1901-1 Log #CP125
(Entire Document)

Recommendation: Completely revise NFPA 1901, Standard for Automotive Fire Apparatus, 2003 edition, as shown in the draft at the end of this report. All text from proposals with affirmative actions have been incorporated in the draft.

1901-2 Log #CP115
(1.1, 1.2 and 1.3.1)

Photo 1: By MFF Martin Grube

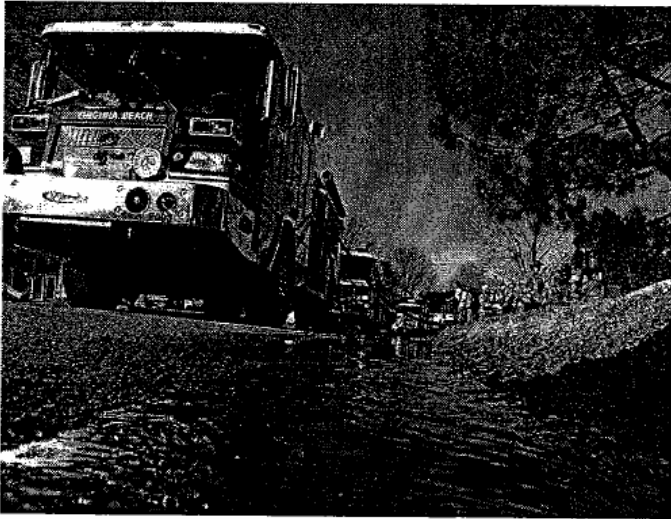
This 2006 Pierce Tiller Truck, (Photo 2), illustrates the same problems noted in the above picture. All audible warning devices are located "as low and far forward" as possible. Photo by Martin Grube

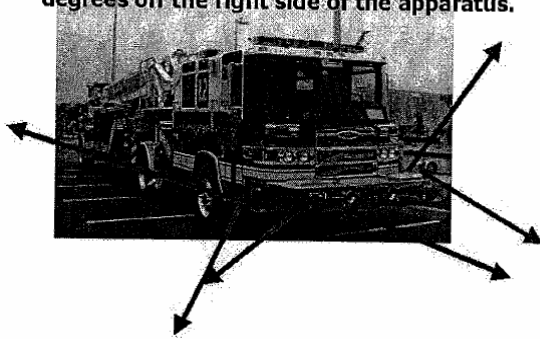
2. The vehicles to the left and right of the forward facing fire apparatus must depend on the depleting +/-50 degree coverage pattern to hear the fire apparatus. Once the fire apparatus makes the intersection, the pattern coming from the front of the bumper is now greatly directed to the front and thus the vehicles approaching from the left and right, opposite travel direction, must now rely on sight of that fire apparatus to react and yield the right of way. See diagram below.

Committee Meeting Action: Reject

Insert photo 3 for proposal 1901-71 Log #109

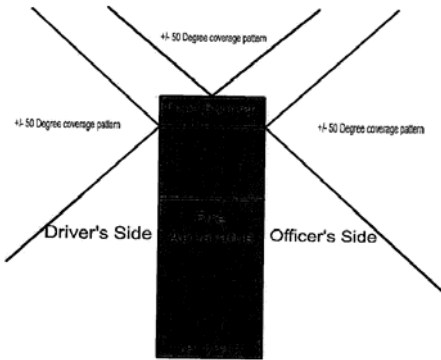
By placing three electric siren horns, the Coverage increases by +/- 50 degrees off The left side of the apparatus and +/- 50 degrees off the right side of the apparatus.

Insert figure 1 for proposal 1901-71 Log #109

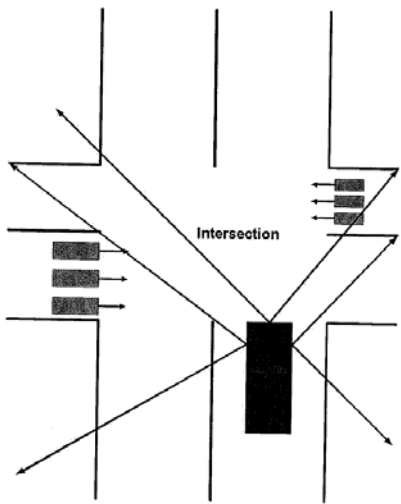
This diagram depicts the desired location of three electric sirens.

FIGURE 14.1.3.3 Dimension Lines for Measuring Seat Belt Effective Length

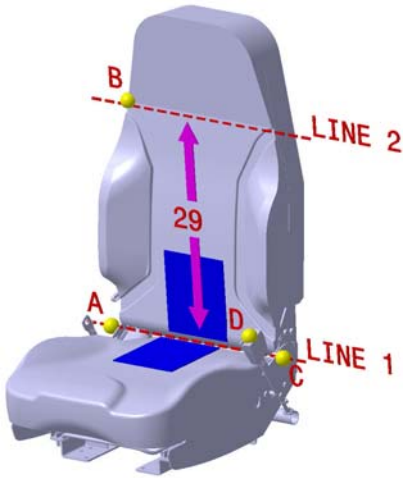
(1) Locate an imaginary line where the plane of the center of the seat back surface intersects the plane of the center of the seat cushion surface (Line 1 in Figure 14.1.3.2). For seats with an SCBA seat back, use a plane that simulates the position of an SCBA back pad installed in the SCBA holder.

(2) Locate an imaginary line parallel with line 1 and lying on the center of the seat back surface 29 in. (740 mm) from line 1 (Line 2 in Figure 14.1.3.2).

(9) The effective seat belt web length equals AB + 2CD.

*** Insert 1901 Log CP49 Sub Figure 1901***

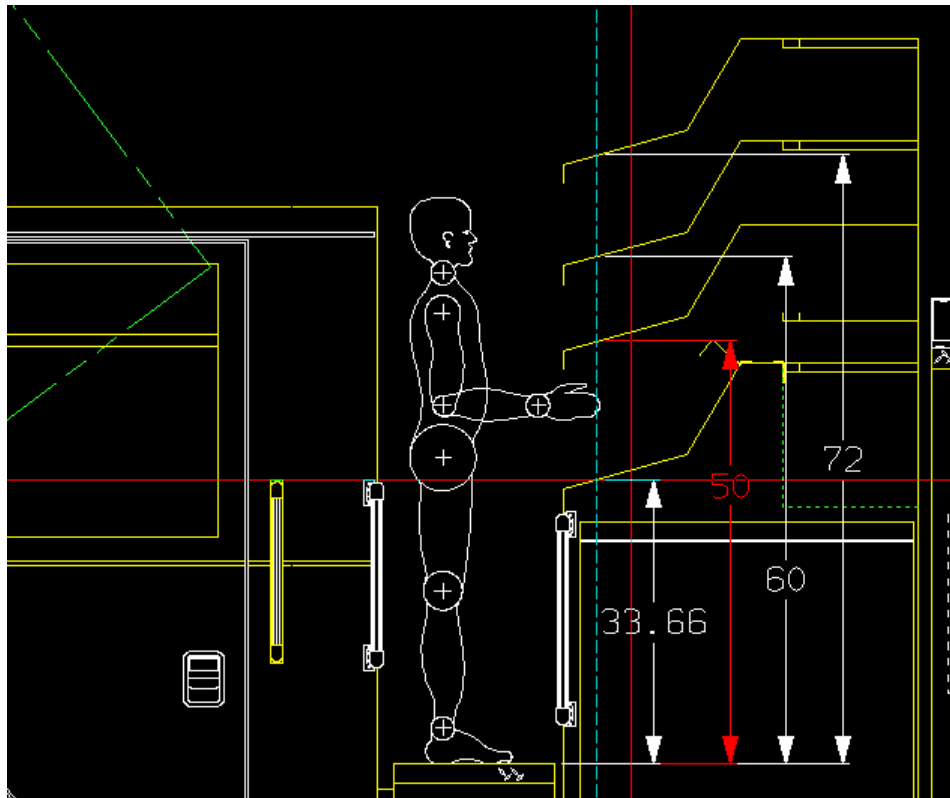
Substantiation: Top mount throttle controls can be mounted lower than 42 in (1070 mm) as measured from the walkway surface to the throttle control. However, since they are mounted on a horizontal surface that faces the operator, a lower mounting is actually easier to operate. Imagine reading a book on a table (typically less than 36 in) while standing versus reading a book against a wall at the same height. Likewise a horizontal surface would be difficult, if not impossible to utilize at 72 in (1800 mm). The drawing below shows the operator (at an average height of 5 ft 7 in.) on the top mount operator's platform. The lowest part of the throttle control panel is 11 in from the edge of the intersection of the lower and upper top mount panels. The lowest part of the throttle control is 33.66" from the top mount platform.

16.11.3 The throttle control on horizontally (less than 45°) arranged pump panels shall be located not higher than 50 in. (1270 mm) nor lower than 32 in. (813 mm) from the operator's standing position with all instruments in full view.

FIGURE A.23.1 Typical Line Voltage Electrical System.

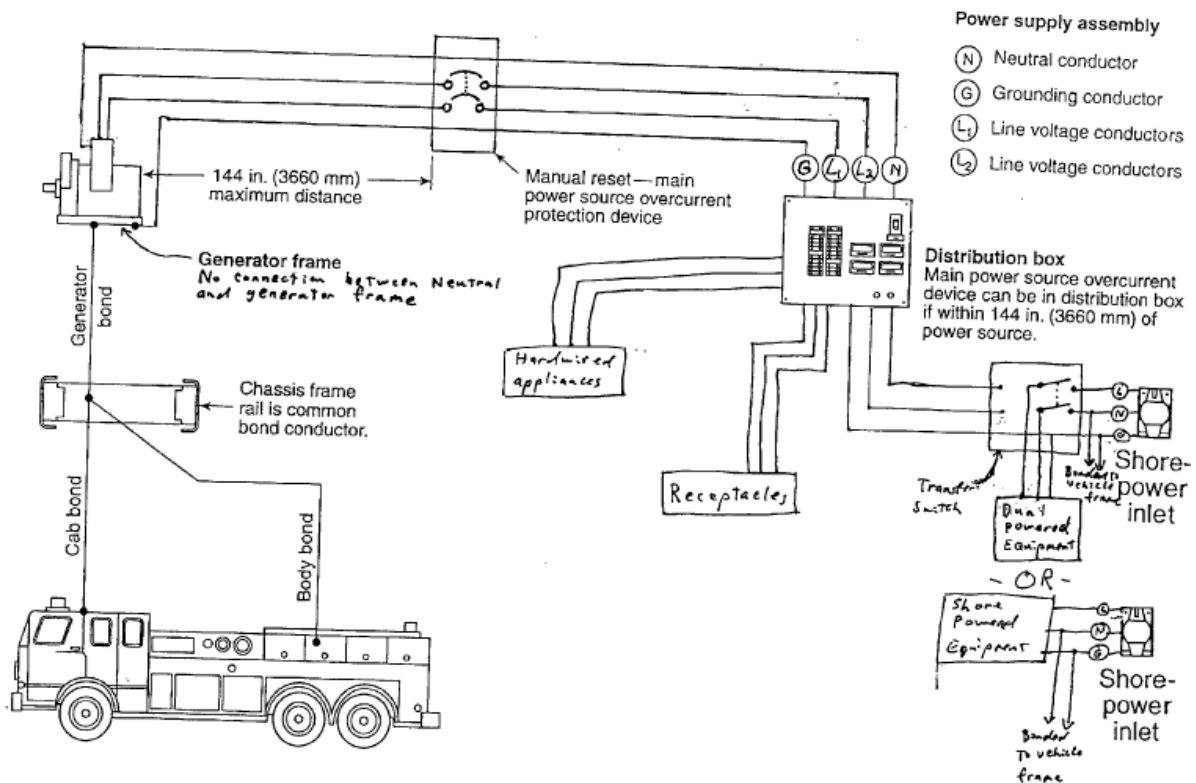
Revise figure A.23.1 to appear as follows:

The change to Figure 23.4.9, and the text of 23.4.9.1 and 23.4.9.2 is to avoid confusion on what wording is to appear on the label.

Figure A.21.2.6(c) Conductivity-Sensing Direct Injection Foam Proportioning System

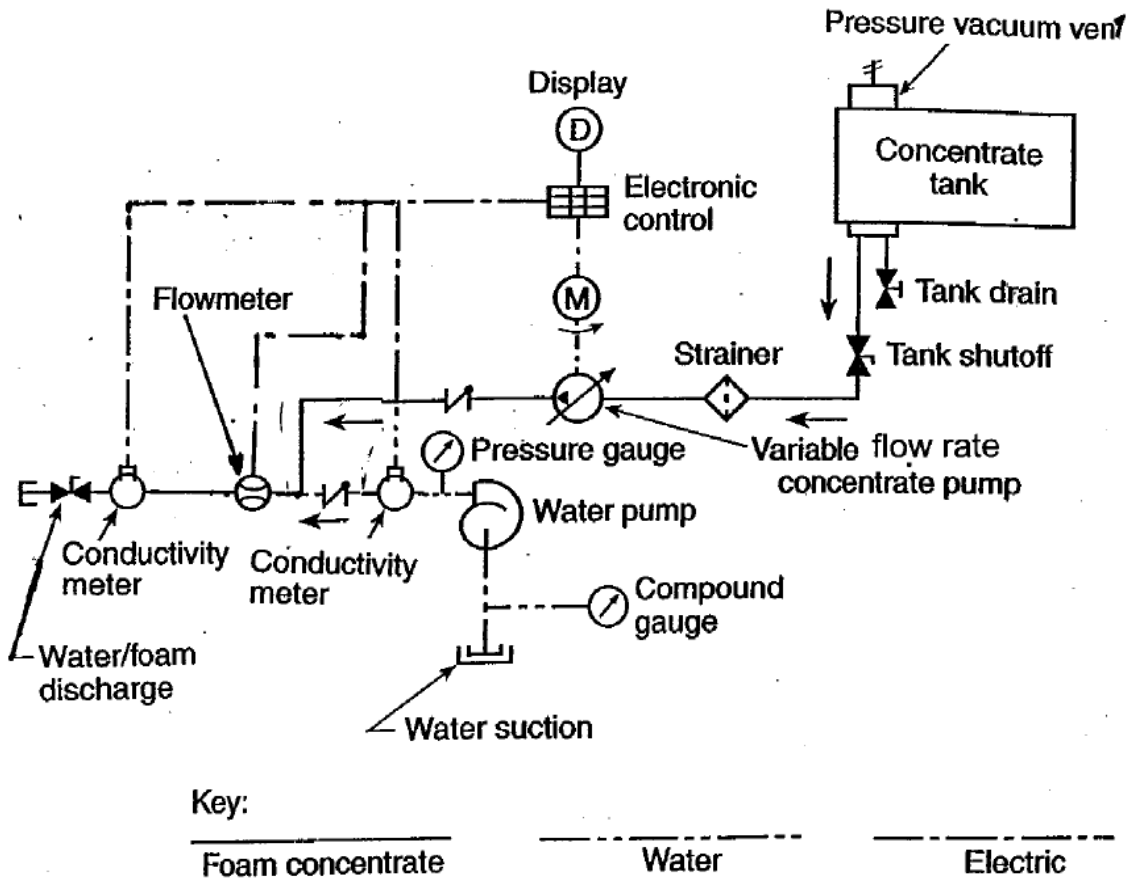
A conductivity-sensing direct injection foam system utilizes an electrical conductivity sensor(s) to sample the fire pump discharge water prior to foam concentrate injection and transmits this information to an electronic control. A second electrical conductivity sensor samples the foam solution and transmits this information to the electronic control that controls the foam pump motor speed based on the ratio selected by the operator. Since flow rate affects conductivity readings, a flow meter transmits the flow rate through the process manifold to the electronic control. [See Figure A.21.2.6(c).]

Revise Figure A.21.2.6(c) to show as:

Substantiation: The revised paragraph more accurately reflects the technology being described.

Committee Meeting Action: Accept
